APPLICATION TO THE OHIO POWER SITING BOARD

FOR AN AMENDMENT TO THE CERTIFICATE OF ENVIRONMENTAL COMPATIBILITY AND PUBLIC NEED FOR

Powell Creek Solar

Case No. 22-0915-EL-BGA

Figure 03-2a

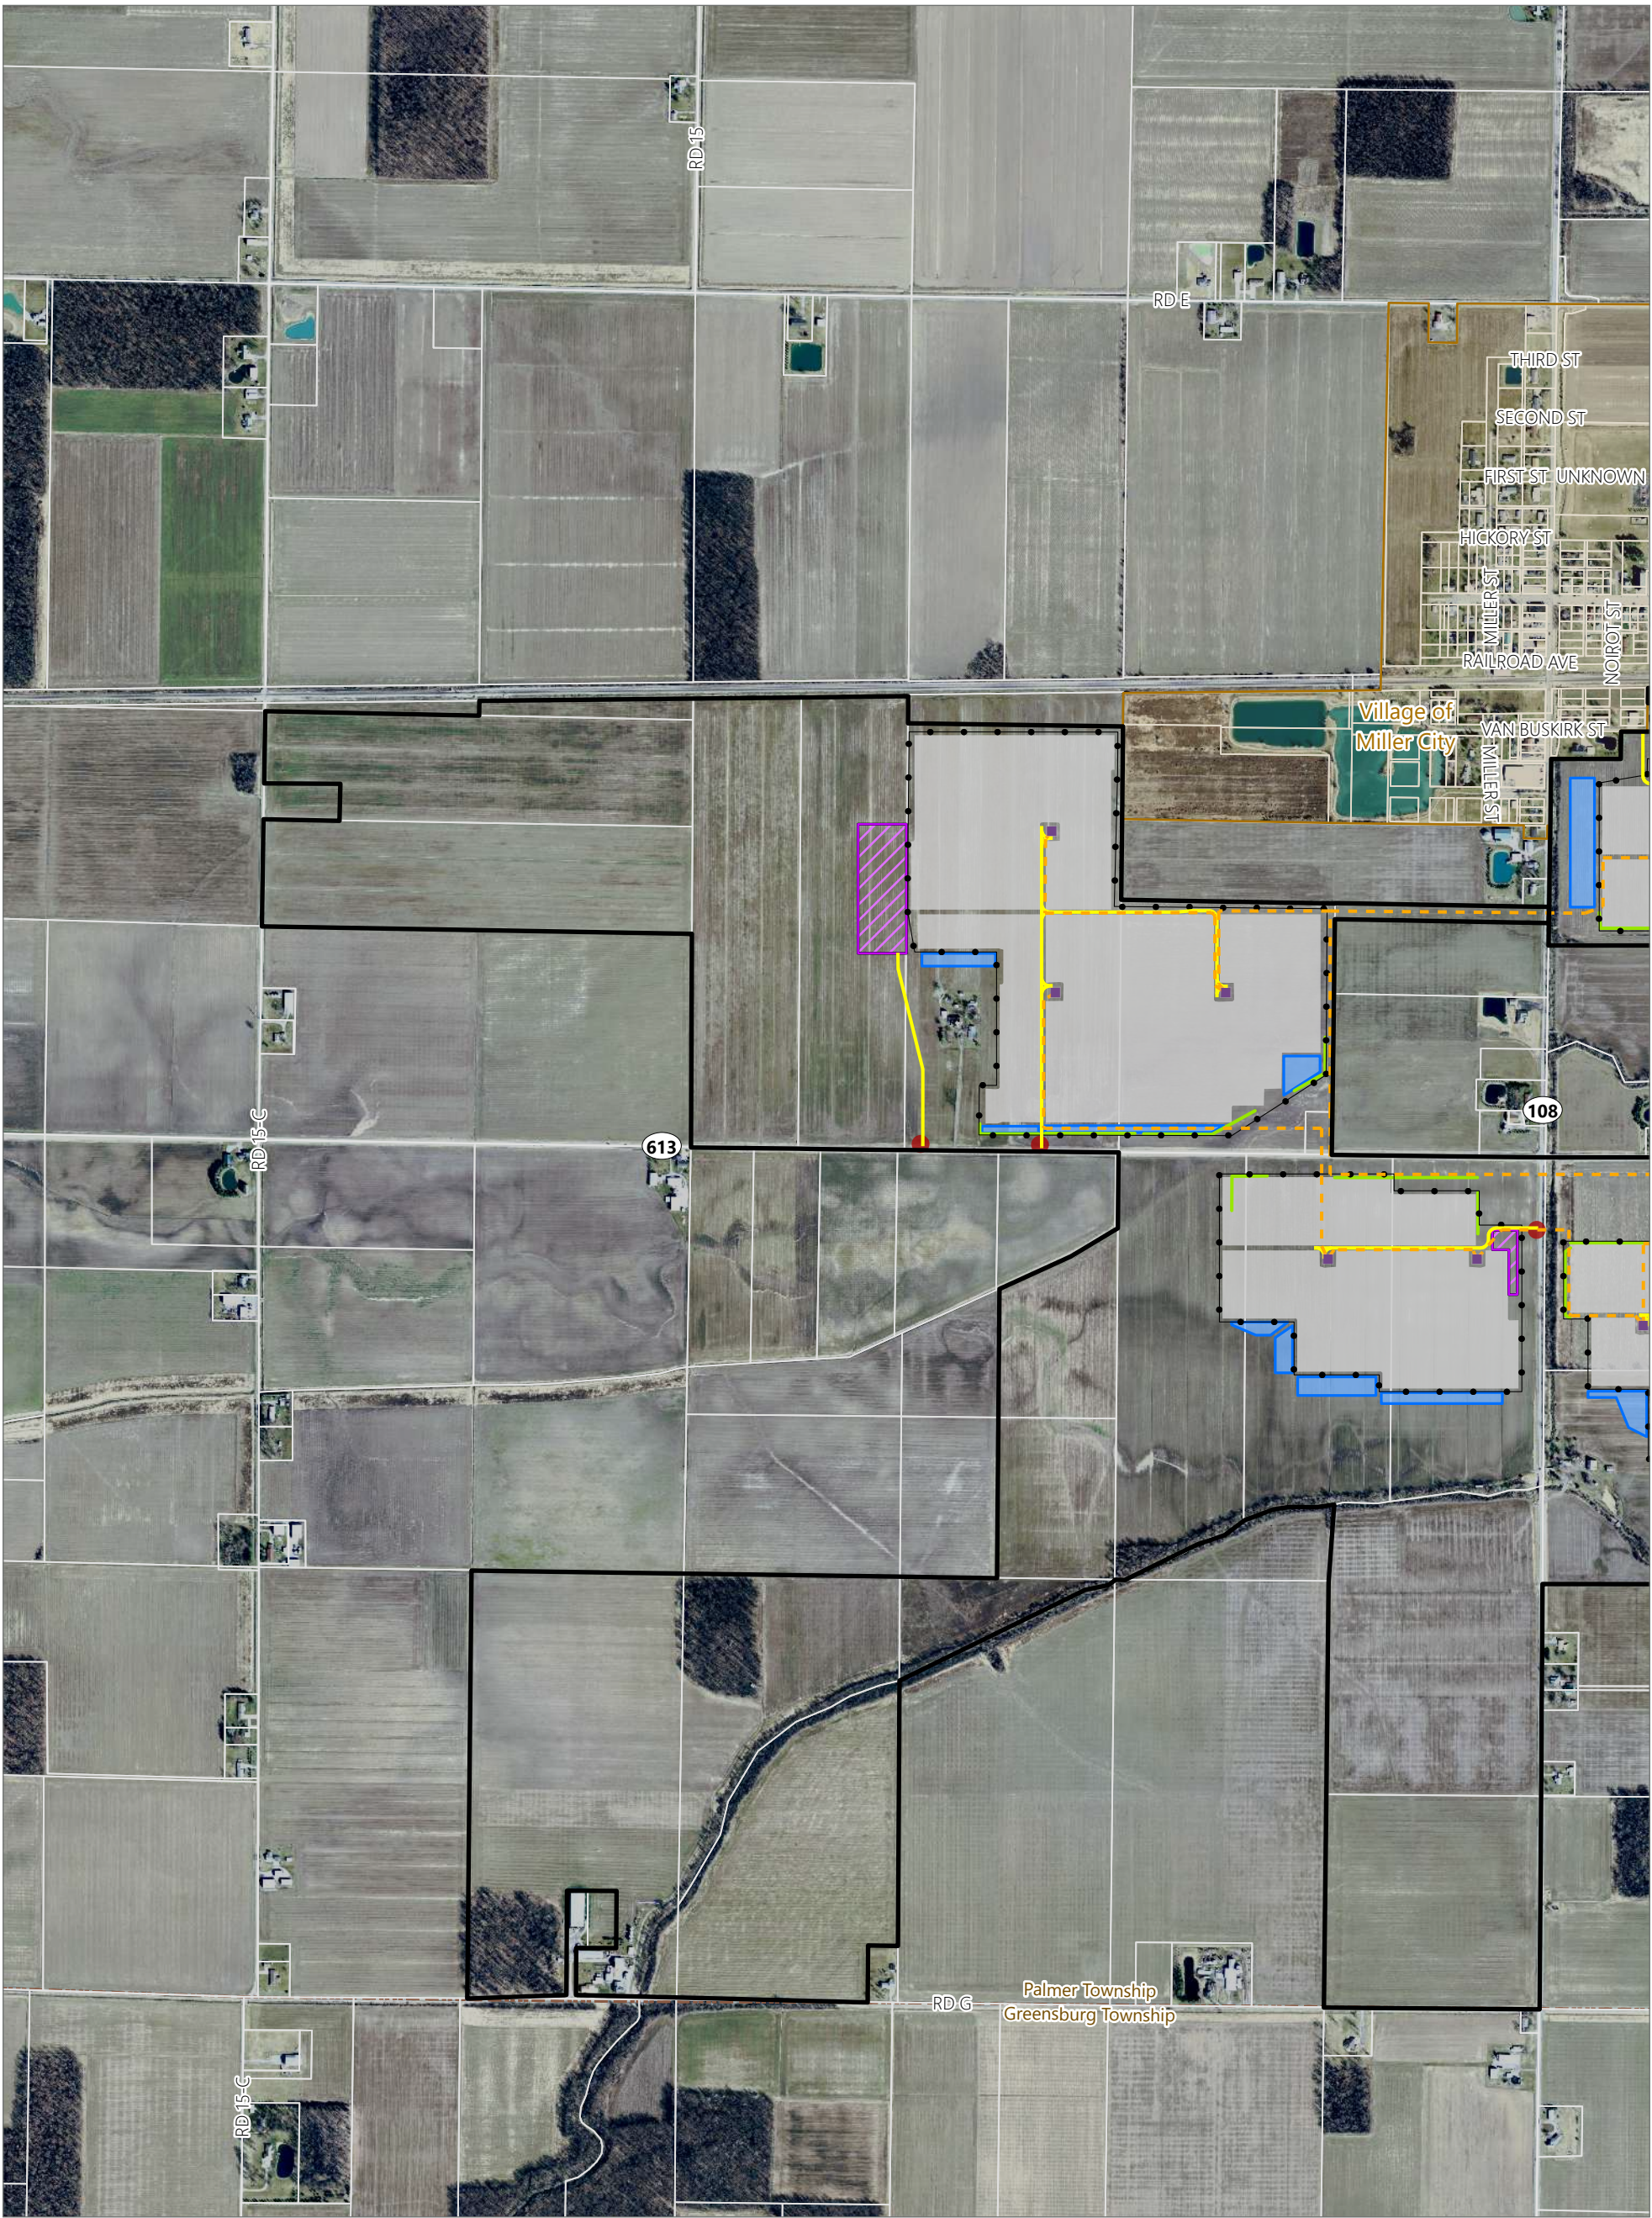
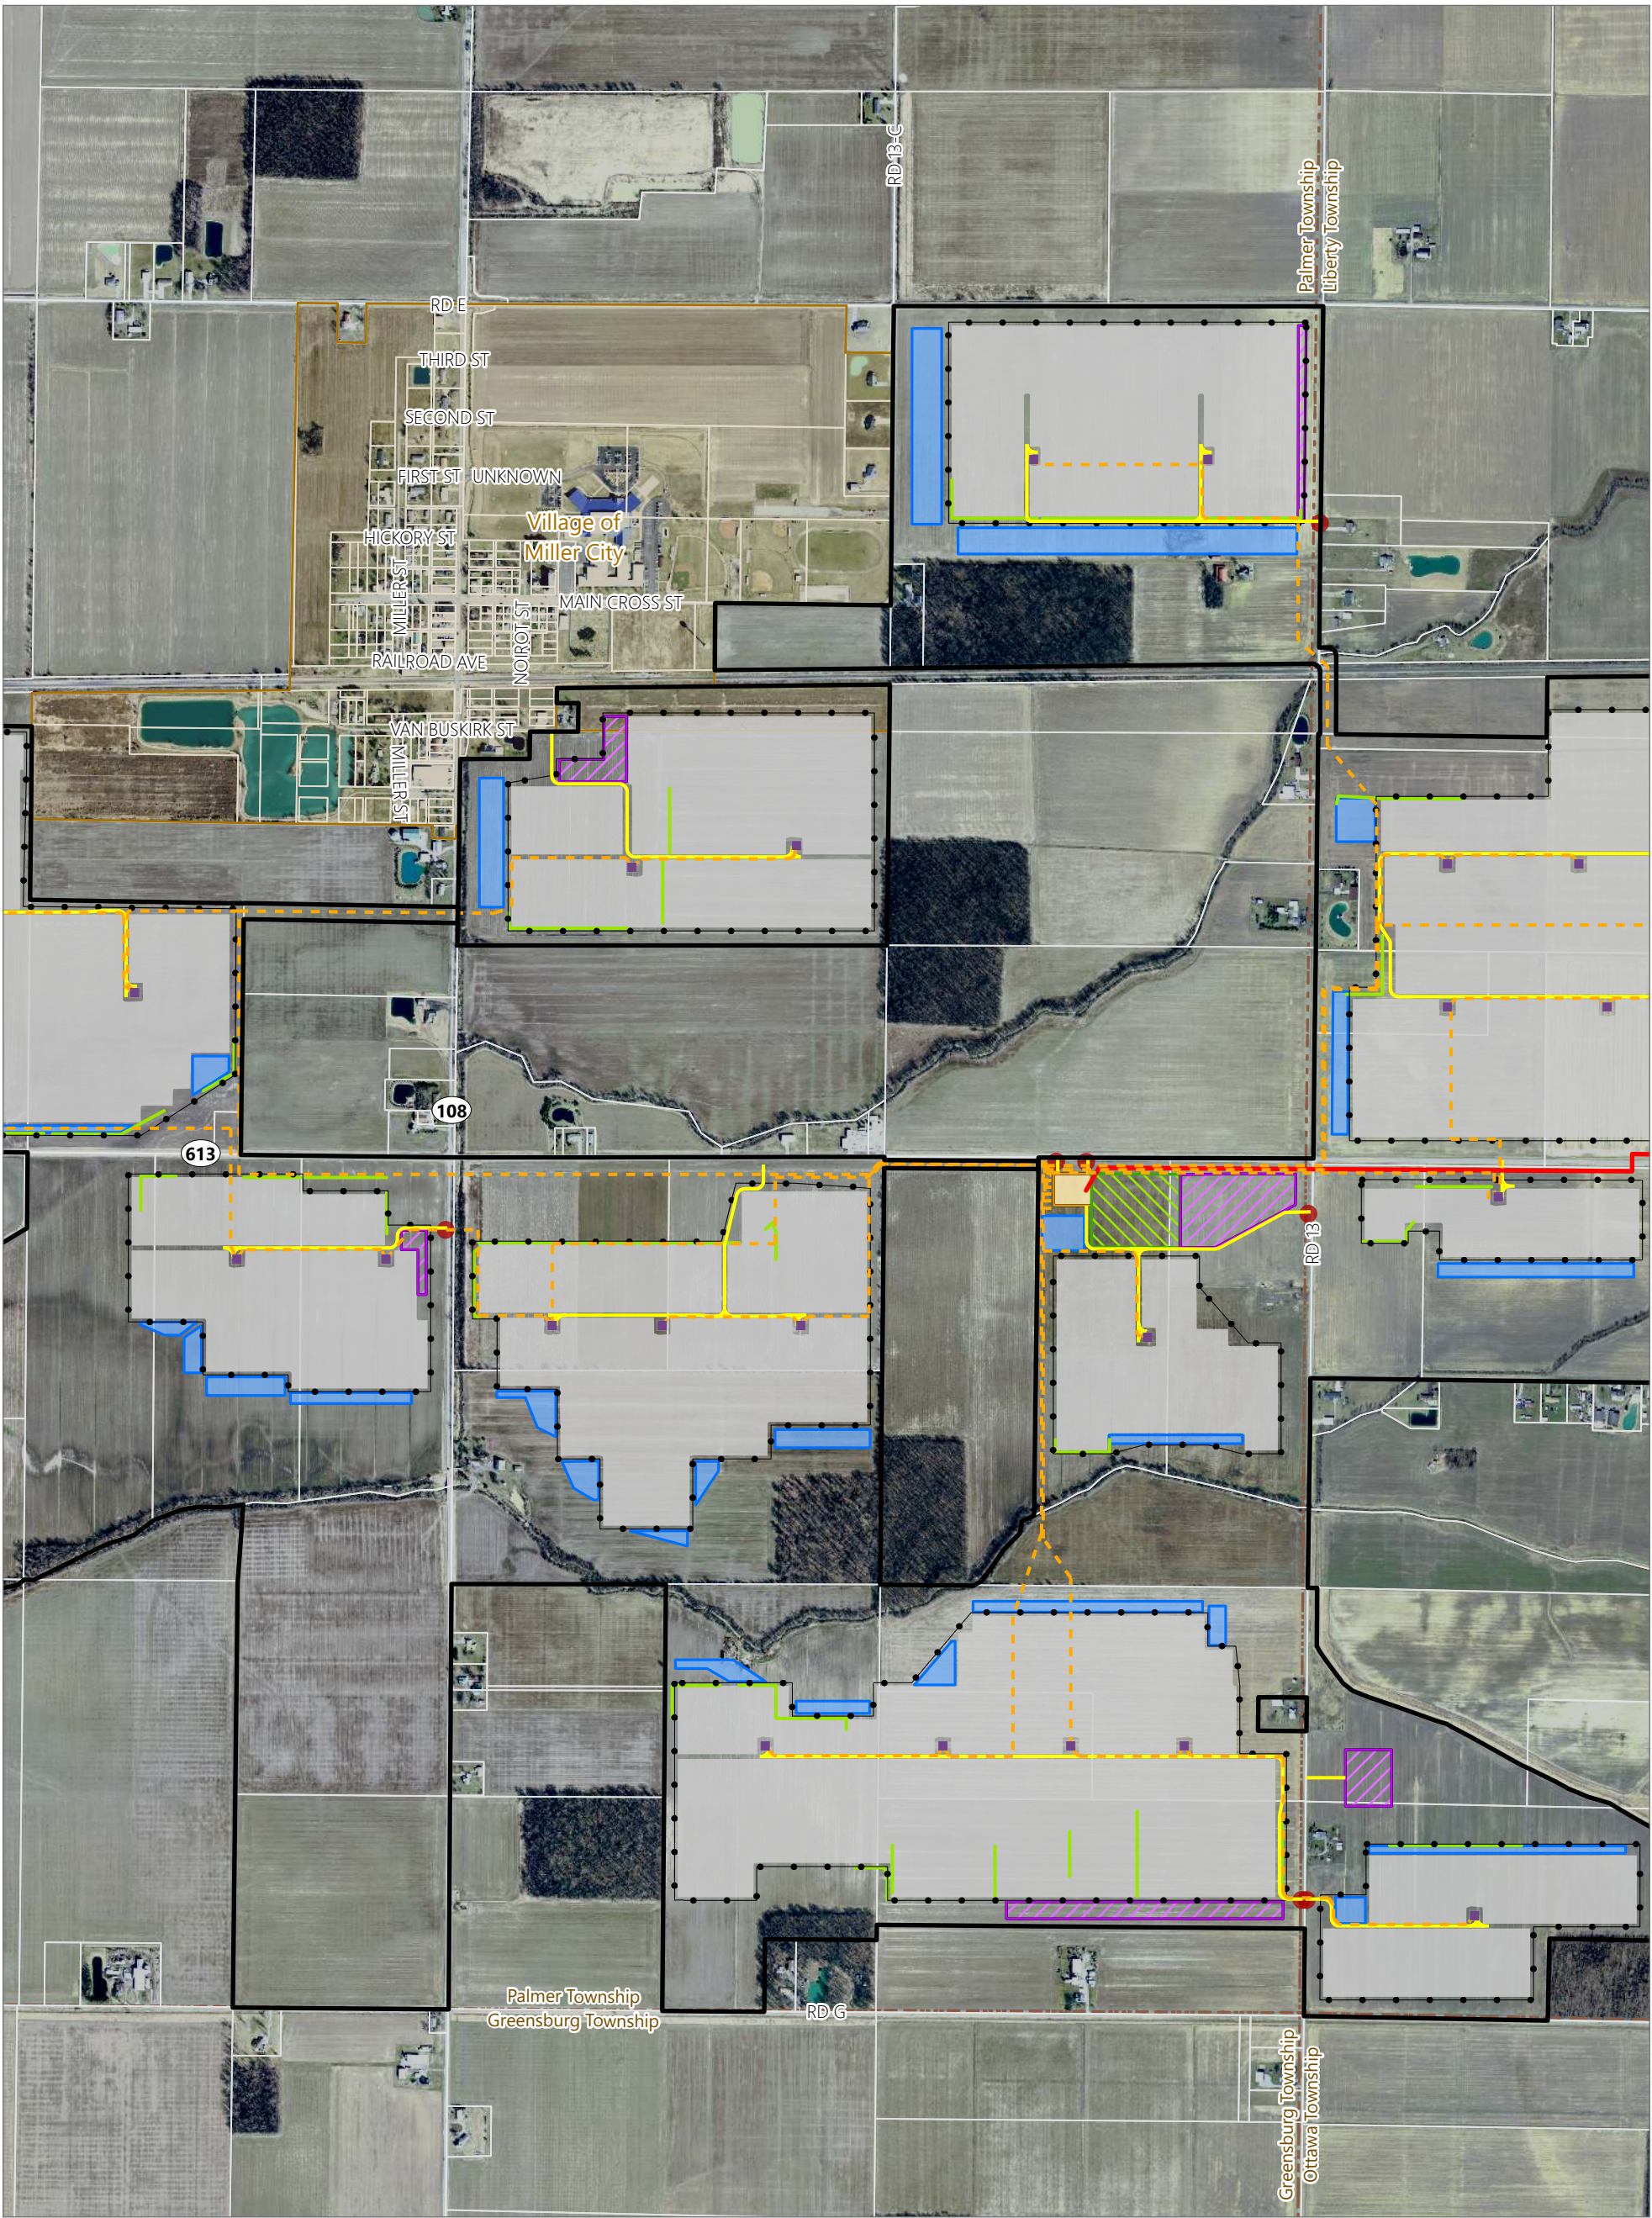
The two additional alternative preliminary Facility layouts, presented in Figure 03-2a and Figure 03-2b, include the fenceline, PV panel area, below ground collection lines, inverters, access roads, collection substation, O&M building, laydown yards, transmission line, and POI switching station contained in the Project Area. While the Applicant expects that the final Facility layout will remain substantially similar to the preliminary Facility layout provided in the Initial Application or the two additional alternative preliminary Facility layouts provided herein, due to ongoing technological innovations in the solar industry, continuing detailed engineering and survey work, public feedback, and communications during the OPSB certification process, the precise locations of these features within the Project Area are subject to change. While the layout is subject to change, all Facility components will be located within the Project Area that has been studied for environmental, cultural, engineering, and visual impacts, and will be subject to the various conditions and constraints provided in this Amendment Application, as well as the requirements of the Certificate issued in the Initial Application case.

The general description of collection lines, circuits, transformers, and installation methods remains the same as filed in the Initial Application. However, the lengths of buried collection cable for each of the additional tracker layouts presented in this Amendment Application are shorter than for the layout in the Initial Application. The ATI layout will require approximately 12.6 miles of buried collection cable, while the STI-PVH layout will require approximately 12.3 miles of buried collection cable. The preliminary design locations for buried collection cable with each tracker design option are shown in Figure 03-2a and Figure 03-2b.

The general description of the substation, the switching station, transformers, inverters, and installation methods remains the same as filed in the Initial Application. For this Amendment Application, the ATI tracker configuration includes 27 inverter locations and the STI-PVH tracker configuration includes 28 inverter locations, as shown in Figure 03-2a and Figure 03-2b.

The general description of Project Area access road size and construction methods, as well as the lack of crane paths, remains the same as filed in the Initial Application. For this Amendment Application, the ATI tracker configuration includes approximately 7.5 miles of access roads and the STI-PVH tracker configuration includes approximately 7.4 miles of access roads. Both measurements include approximately 0.3 mile of access roads that will be temporary, as they only serve to provide access to temporary laydown yards. Access roads are shown Figure 03-2a and Figure 03-2b.
